Subject: Minutes for 60th Protection Sub-Committee Meeting.

60th Protection Sub-Committee Meeting (26th May, 2025)-MoM

Minutes of
60th Meeting of Protection Sub-Committee (PSC) of
Northern Regional Power Committee

Date and time of meeting : 26.05.2025 10.30 Hrs.

PMU Plot of phase voltage at Bikaner(IP)

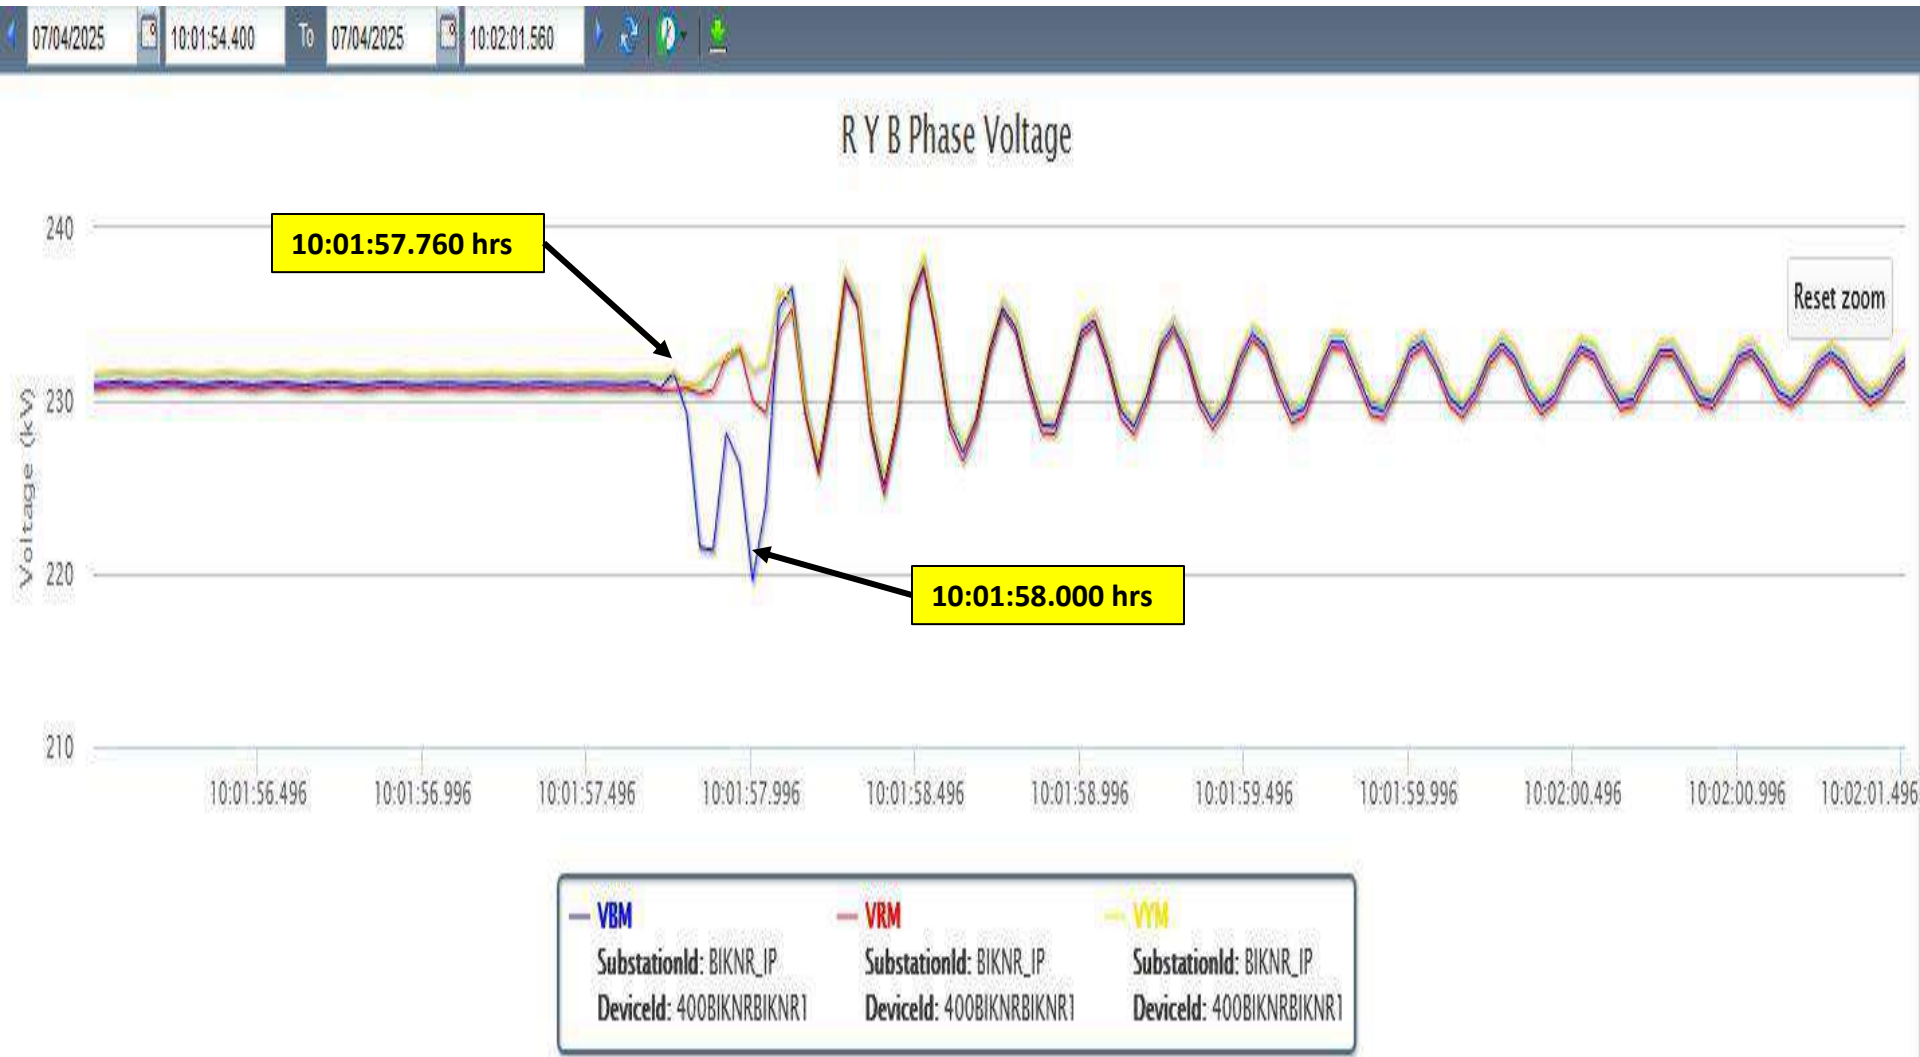
✓ As per PMU, B-N fault is observed with delayed fault clearing time of 240ms.

DR of Busbar relay at Fatehabad(HV)

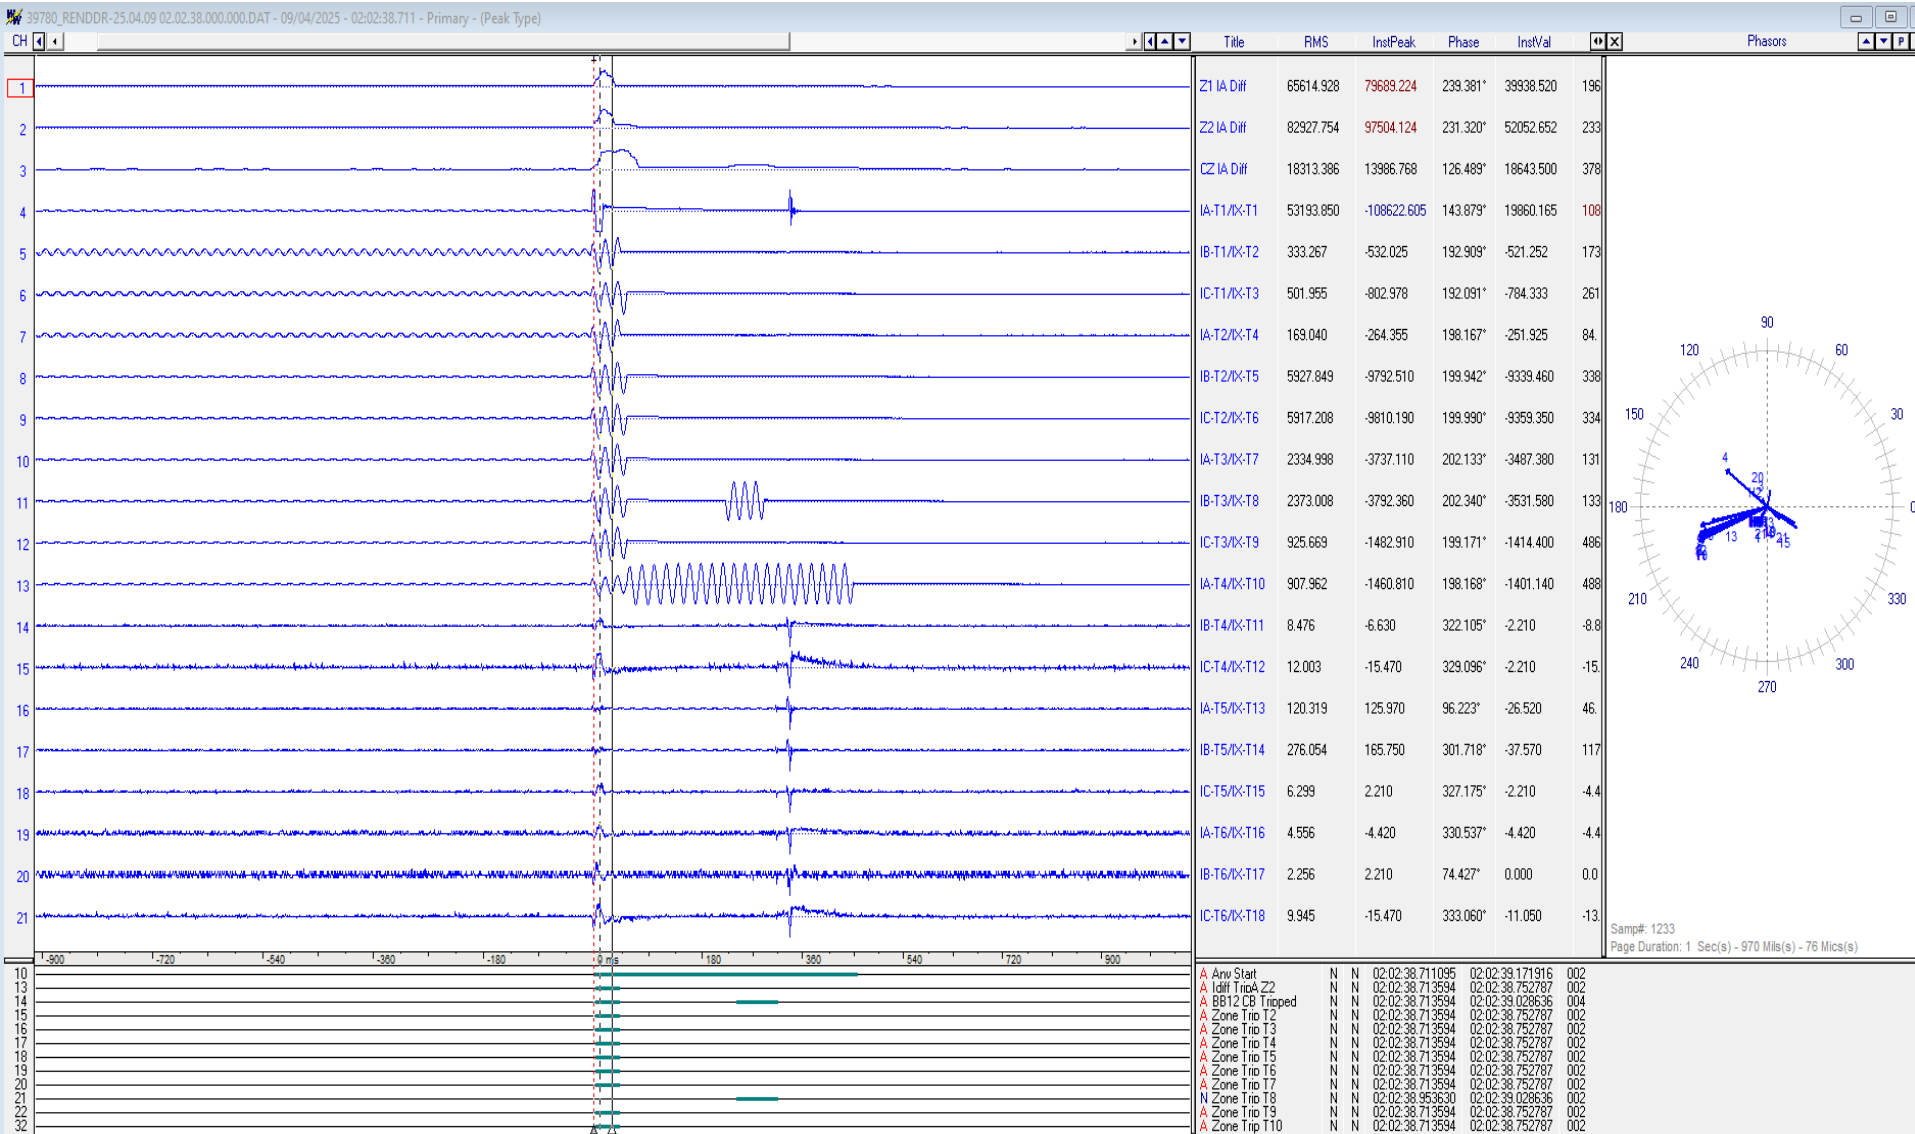
✓ Zone-2 busbar differential operated

DR of 220 KV DandhariKalan(PS)-Ludhiana(PG) (end) (PSTCL) Ckt-1

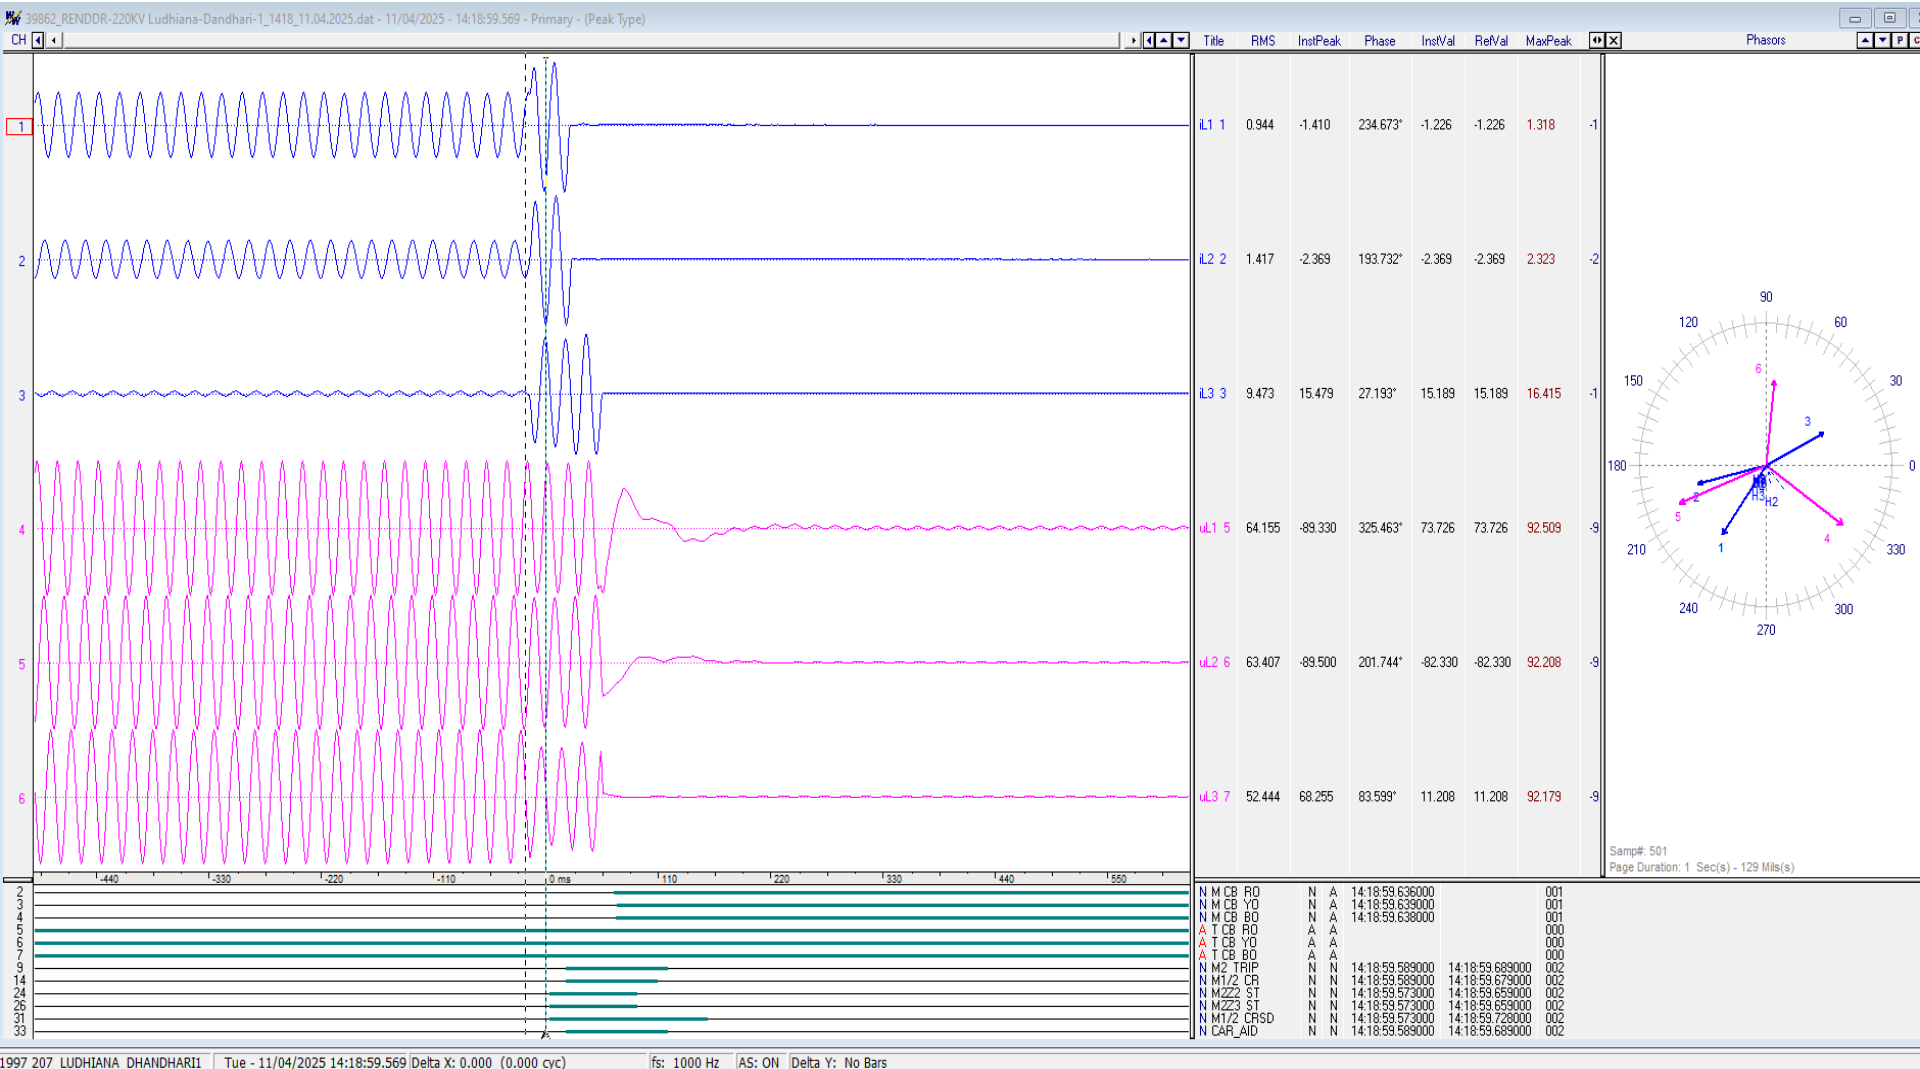
- ✓ B-N phase to earth fault; $I_b \approx 9.473 \text{ kA}$
- ✓ Fault sensed in zone-2; Carrier-aided trip
- ✓ Fault clearing time $\approx 70 \text{ ms}$

DR of 220 KV DandhariKalan(PS)-Ludhiana(PG) (end) (PSTCL) Ckt-2

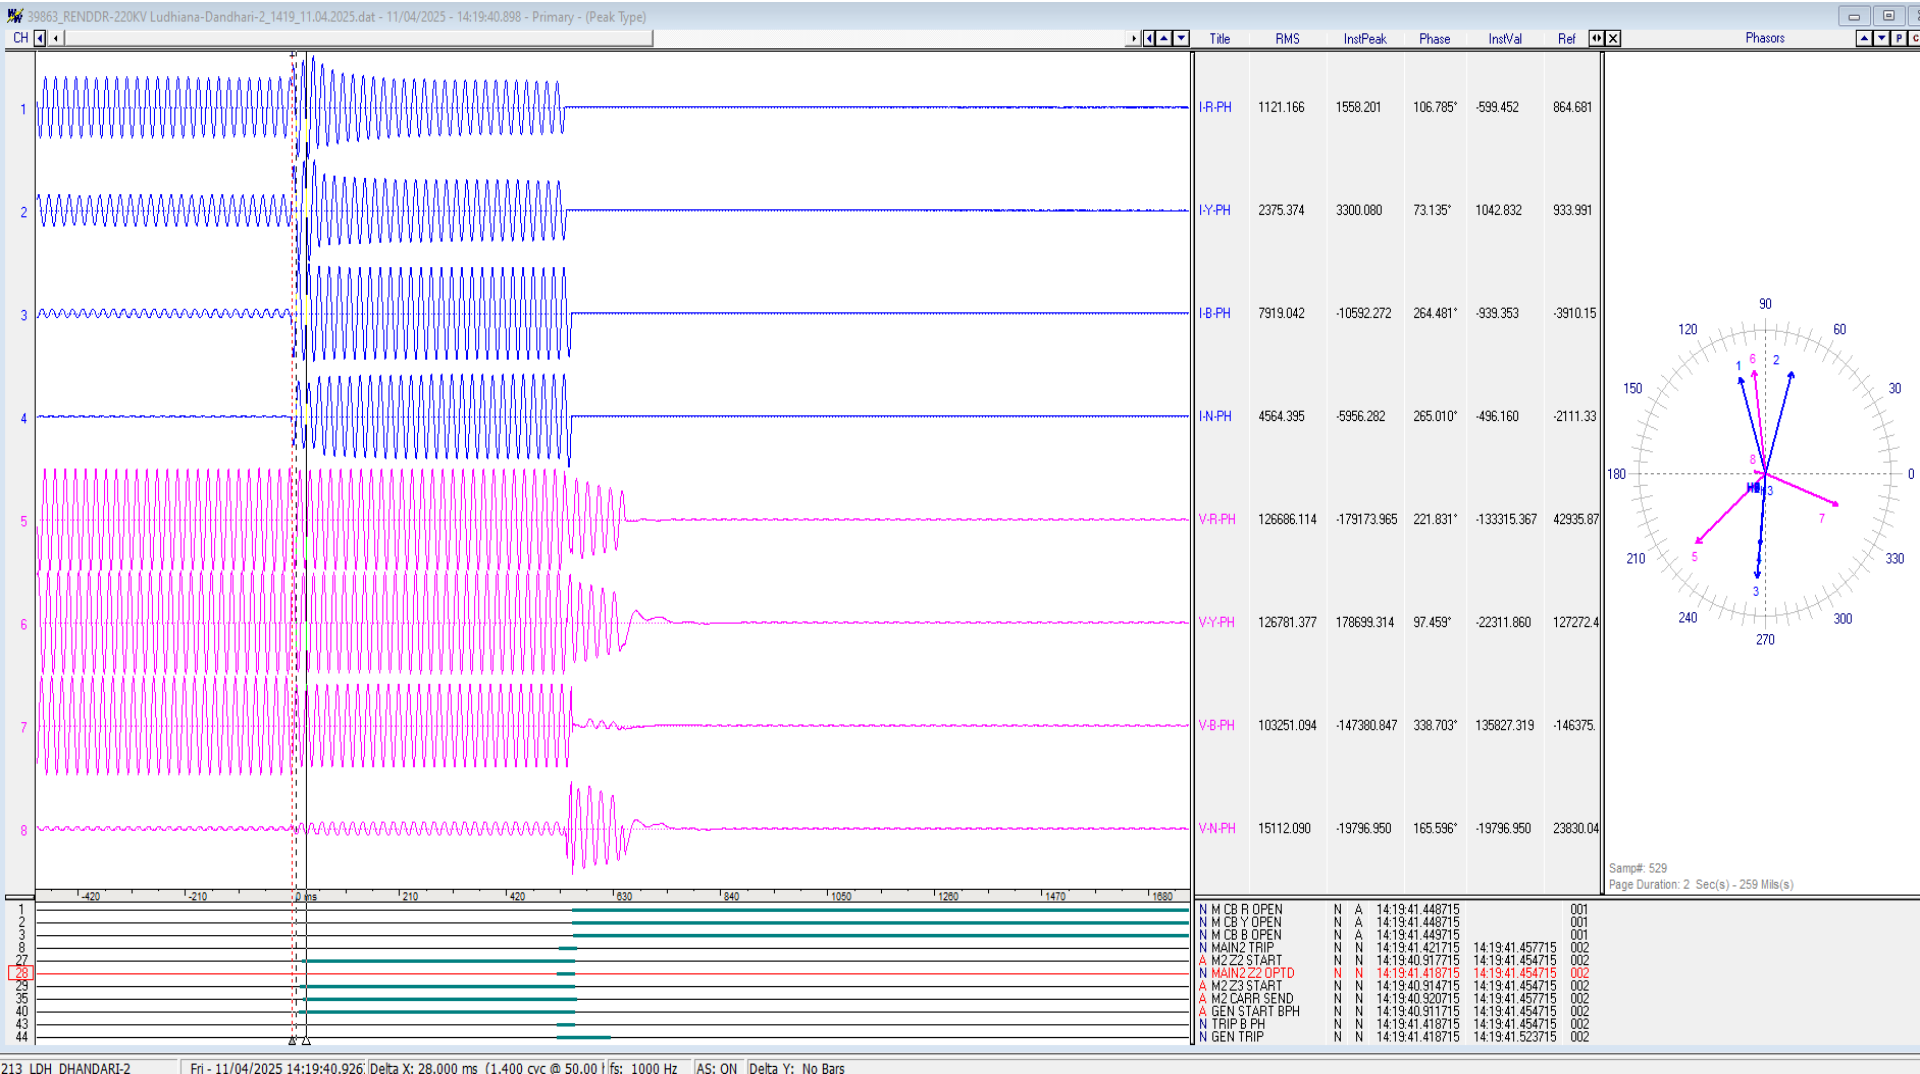
- ✓ B-N phase to earth fault; Ib=~7.919kA
- ✓ zone-2 protection operated
- ✓ Fault clearing time=~550ms

DR of 220 KV Kanpur(PG)-Unchahar(NT) (end) (PG) Ckt-1

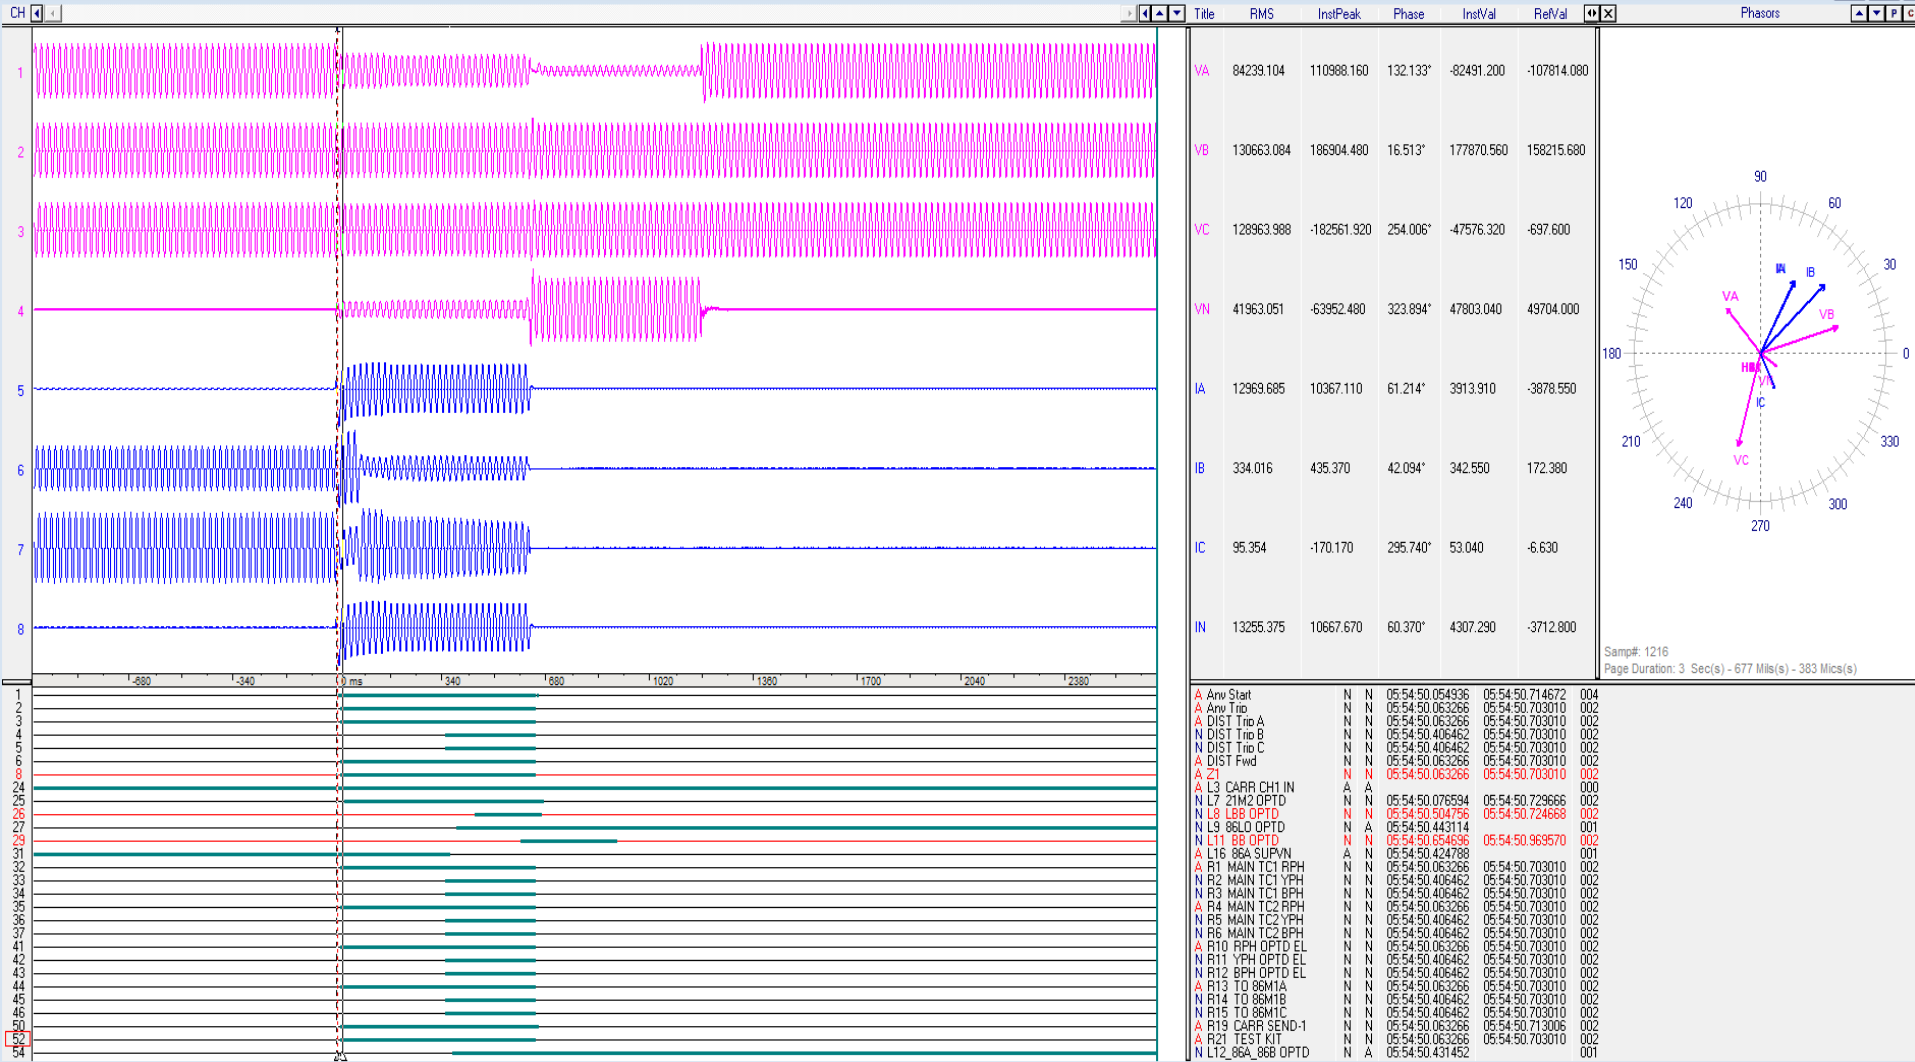
- ✓ R-N Phase to earth fault; $I_r \sim 12.97\text{kA}$
- ✓ Fault sensed in zone-2
- ✓ LBB operated
